E5052A-03

S E R V I C E N O T E

E5052A Signal Source Analyzer

A2 Board Not Seated in the Slot Properly

Figure 1 Boot up error message

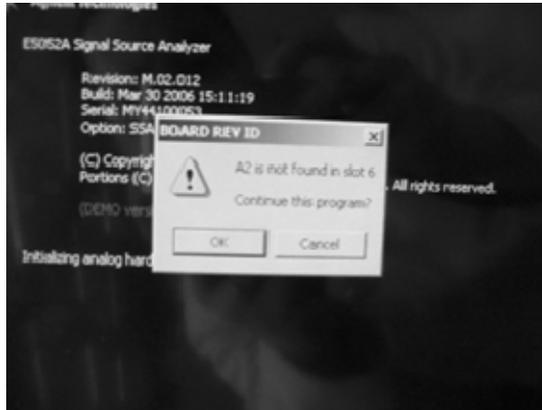
“A2 not found in slot 6” error message is displayed and E5052A firmware does not start up while windows 2000 operating system has been started. (See Figure 1)

Figure 2 A2 not seated properly (bottom view)

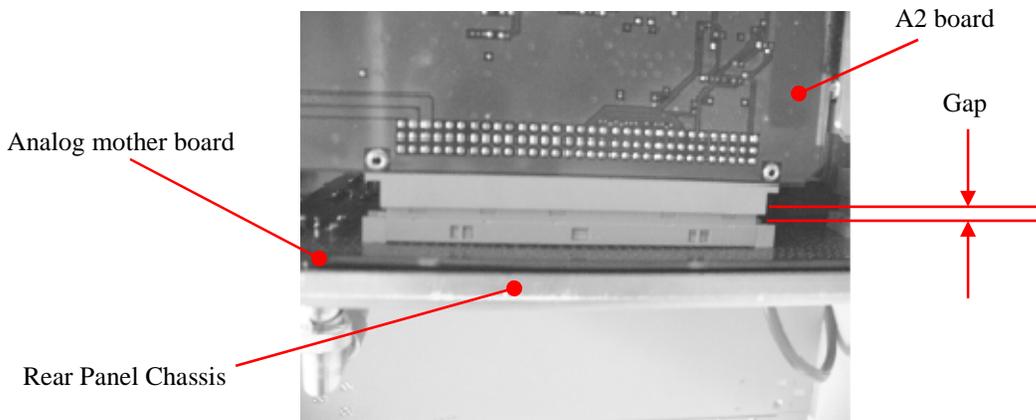
This error is displayed when A2 board is not seated properly and lost the connection to the analog mother board (see Figure 2) due to the flange of both A2 board and chassis is mechanically transformed during transportation (see Figure 3).

Figure 4 A2 shield case (bottom) assembly

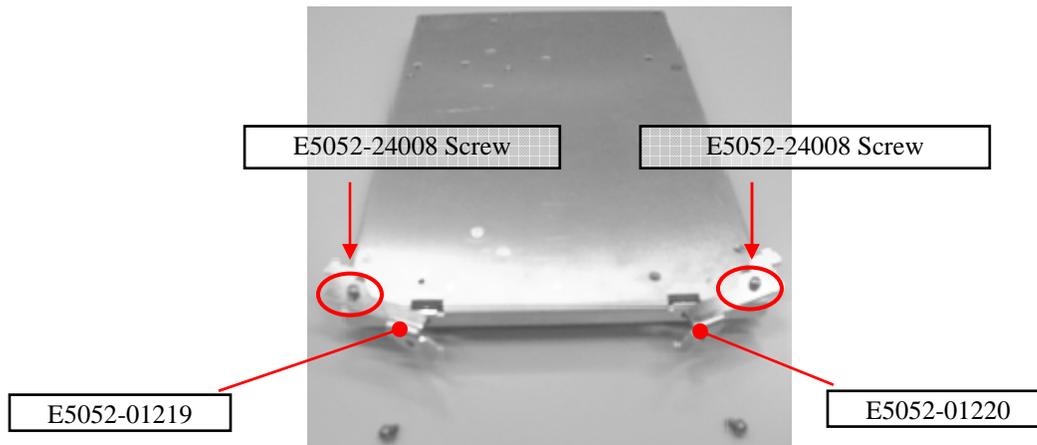
Step1. Attach E5052-01219 and E5052-1220 to the E5052-00624 with screw (see Figure 4)

Figure 5 Old (E5052-00621) and New (E5052-00624) shield case

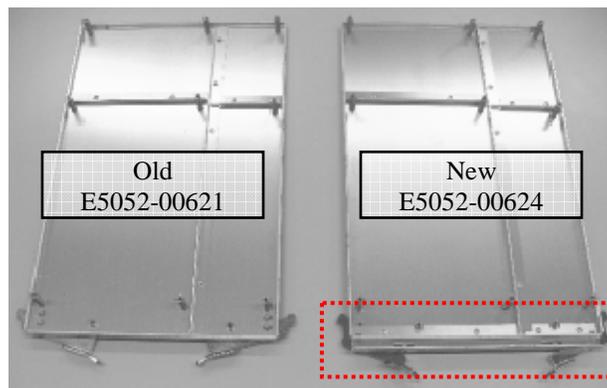
Step4. Remove A2 shield case (E5052-00621) and replace it with the new one (see Figure 5)

OLD P/N	NEW P/N	Description
E5052-00621	E5052-00624	Case Shield
N/A	E5052-01219	Extractor
N/A	E5052-01220	Extractor
N/A	E5052-24008	Screw

Figure 6 Replace A2 shield case (bottom cover) with E5052-00624

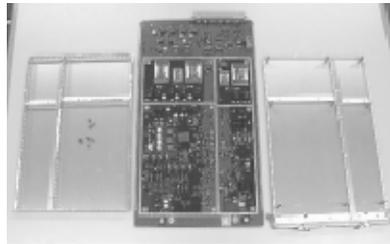
Remove top shield case

Replace bottom shield case with E5052-00624

Figure 6 Install the A2 board back in the slot and put connectors back on the board

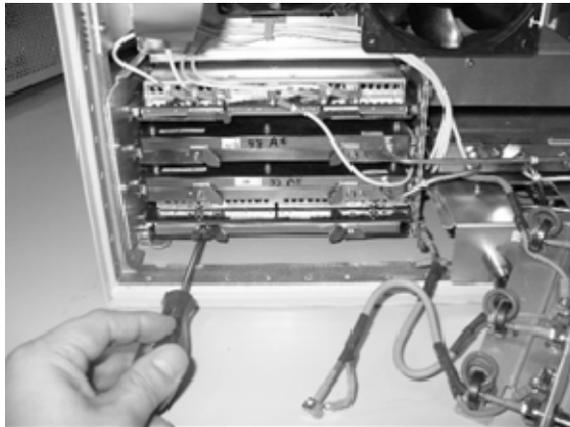
Step4. Install the A2 board back in the slot (see Figure 6)
